Amendments to the Drawings:

Remarks:

FIG. 7
 PRIOR ART

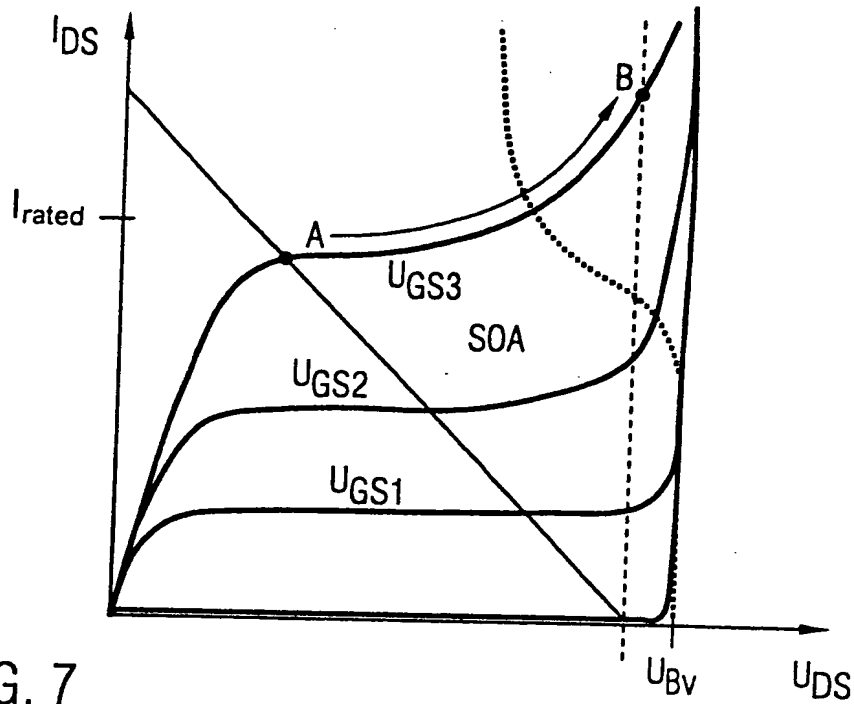
In item 4 of the above-identified Office Action, the drawings were objected to for not including the legend "Prior Art" in connection with Figs. 7 and 9. Figs. 7 and 9 have been amended to include the "Prior Art" label. Substitute sheets including the amended Figs. 7 and 9 are included herewith. Additionally, red-lined sheets, showing the amendments made to Figs. 7 and 9, are additionally included herewith.

Figs. 7 and 9 have been amended to include the "Prior Art" label. Substitute sheets including the amended Figs. 7 and 9 are included herewith. Additionally, red-lined sheets, showing the amendments made to Figs. 7 and 9, are additionally included herewith.
